Letter to the Editor

Comment on “A strategy of estimating fuel concentration in a direct liquid-feed fuel cell system” [Y.J. Chiu, H.C. Lien, *Journal of Power Sources* 159 (2006) 1162–1168]

Fig. 1. The quad cell voltage as a function of time. Every 17 h, the air supply to the cathode was turned off for 7 h [2].

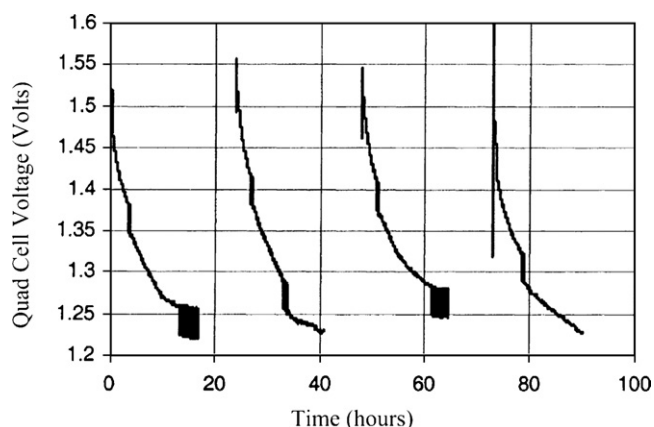
The strategy for estimating the methanol concentration in a direct methanol fuel cell (DMFC) proposed by Chiu and Lien [1] is based on the assumption that the performance of a DMFC does not degrade. In fact, the cell voltage will always go down after a few hours operation due to performance degradation (PD) [2–5]. For example, the voltage change with time for a DMFC stack developed at Motorola is shown in Fig. 1 [2]. Consequently the concentration estimated by Chiu and Lien's method might be less than the true concentration after the cell has been working a few hours. When developing the strategy for estimating the methanol concentration, the authors should take the PD into consideration. However, it will be a difficult task as the degradation rate of a DMFC is affected by many working factors.
